Groundwater Transfer Review Summary Form

Transfer/PA # T- 14924

Ground Water Review Form:

Application: T-14924

Map

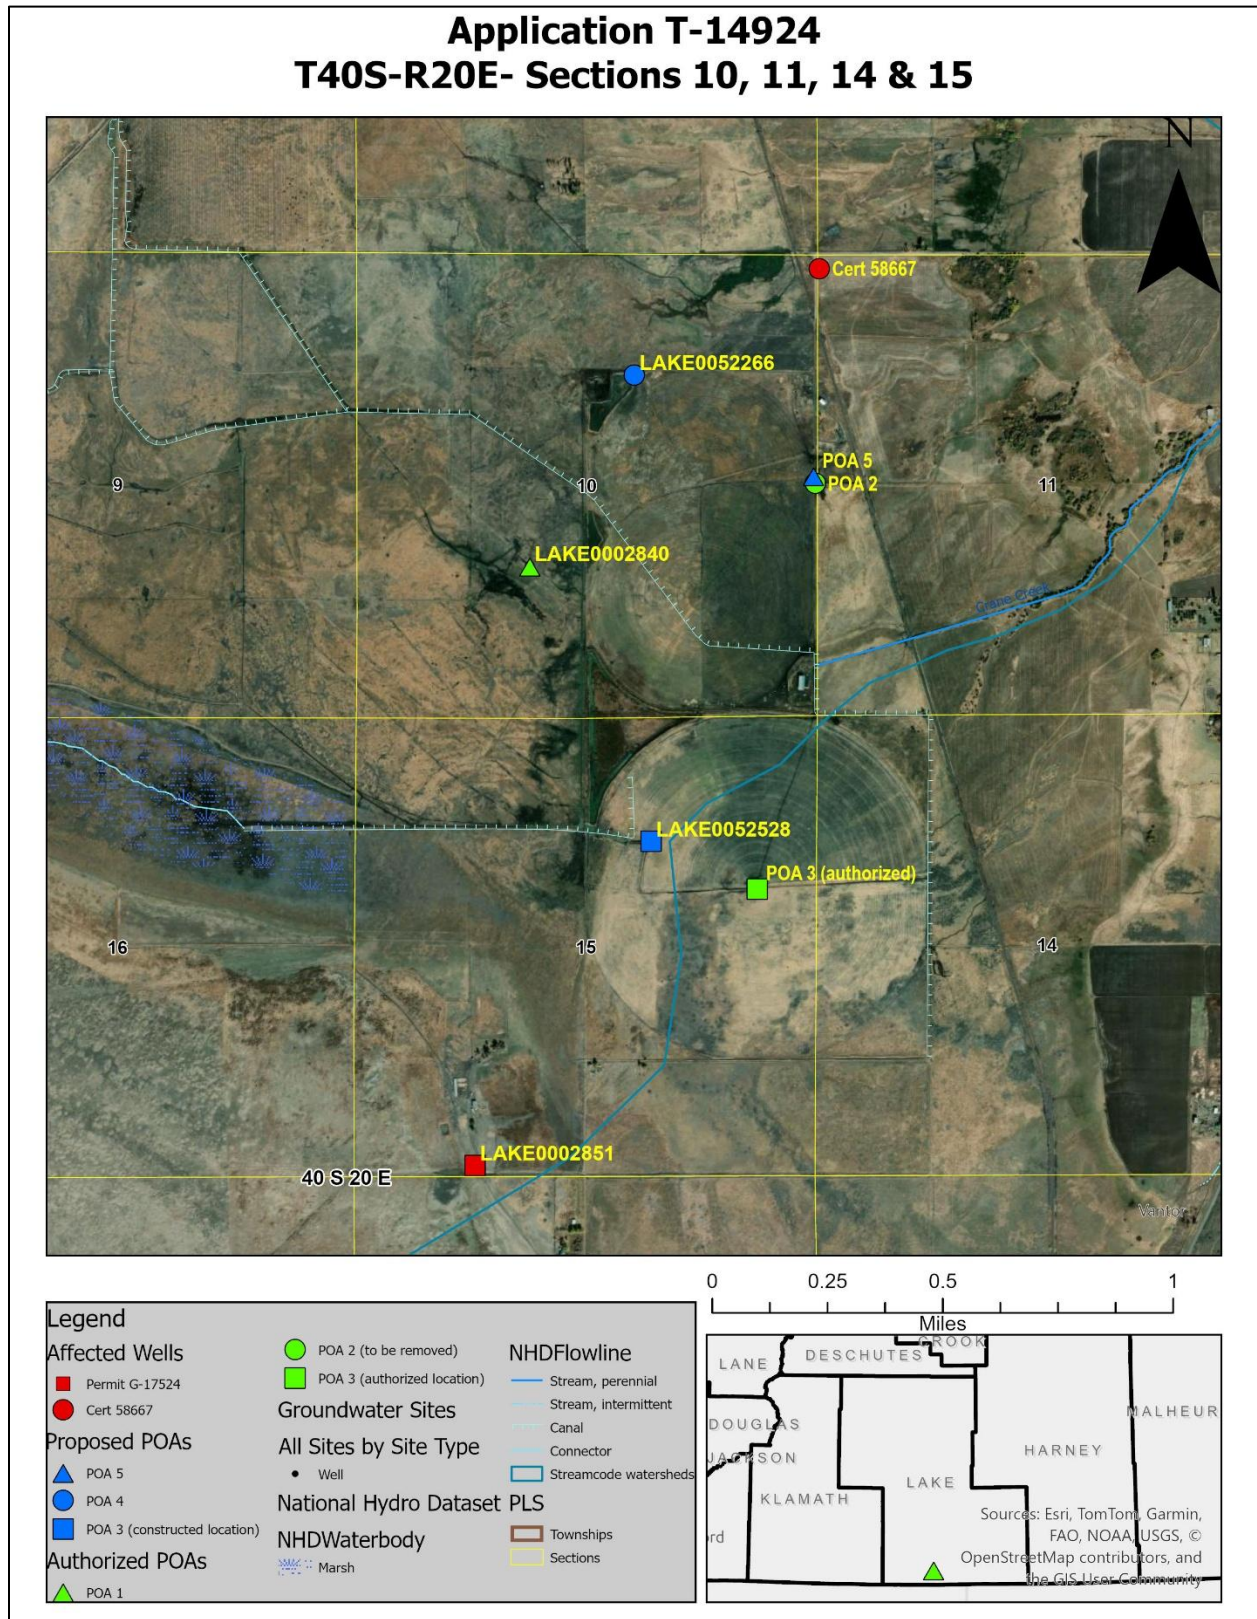
b) If yes, estimate the portion of the right supplied by each of the sources and describe any limitations that will need to be placed on the proposed change (rate, duty, etc.): _____
5. a) Will this proposed change, at its maximum allowed rate of use, likely result in an increase in interference with **another ground water right**?
☒ Yes ☐ No Comments: LAKE 52528 is closer to LAKE 2851 than the authorized location for POA 3 and the proposed location for POA 5 is moving closer to the POA for Certificate 58667. These reduced distances to nearby groundwater POAs will likely result in an increase in interference.

Calculated Drawdown

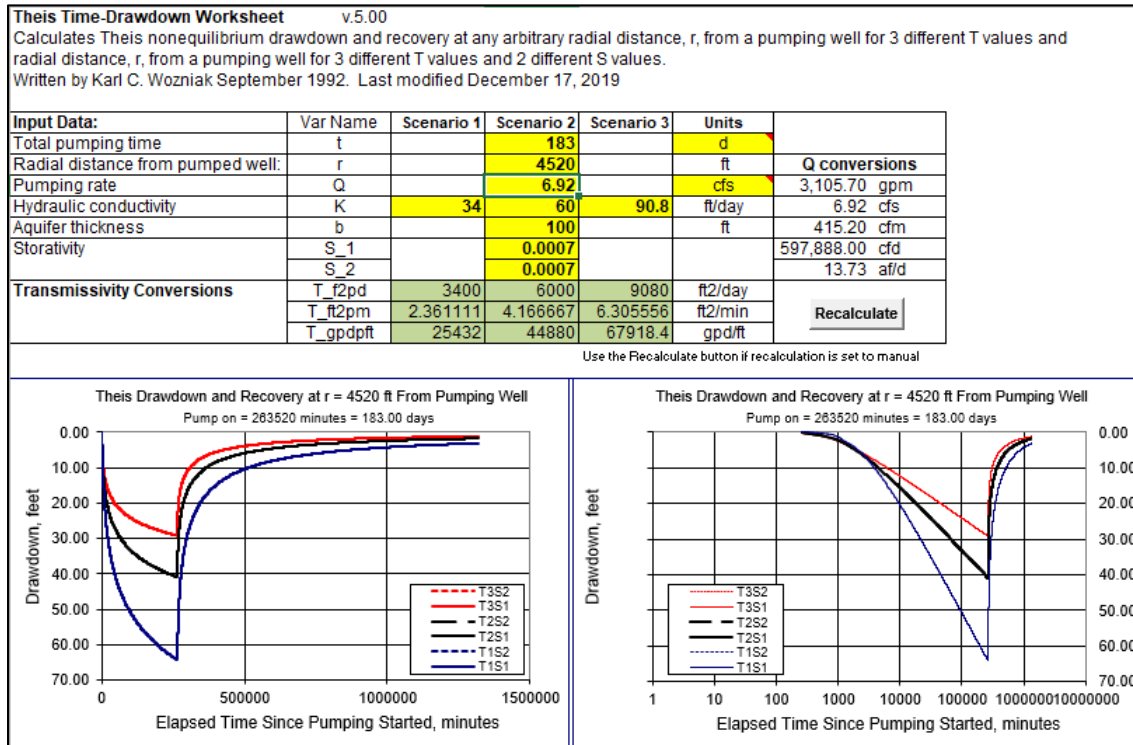
☐ Yes ☒ No If yes, explain: Drawdown for POAs 3 and 5 were calculated using estimates using the Theis (1940) equation. Transmissivity values used in this estimate range from 3400 – 9080 ft²/day were taken from a pump test from nearby well, LAKE 2851, and from Morgan (1988). The storage coefficient used, 0.0007, was taken from Morgan (1988). A maximum rate of 6.92 CFS was used for 183 days of continuous pumping to provide a conservative estimate of drawdown.

The constructed location for LAKE 52528 is 300 ft closer to LAKE 2851 than the authorized location for POA 3 and results in an additional 1.9 ft of estimated drawdown in affected well. The proposed location for POA 5 is 50 ft closer to the POA for Certificate 58667 and results in an additional 0.58 ft of estimated drawdown in the affected well. This relatively small increase in drawdown would likely not cause injury to nearby groundwater rights and isn't expected to meet the definition of substantial or undue interference.
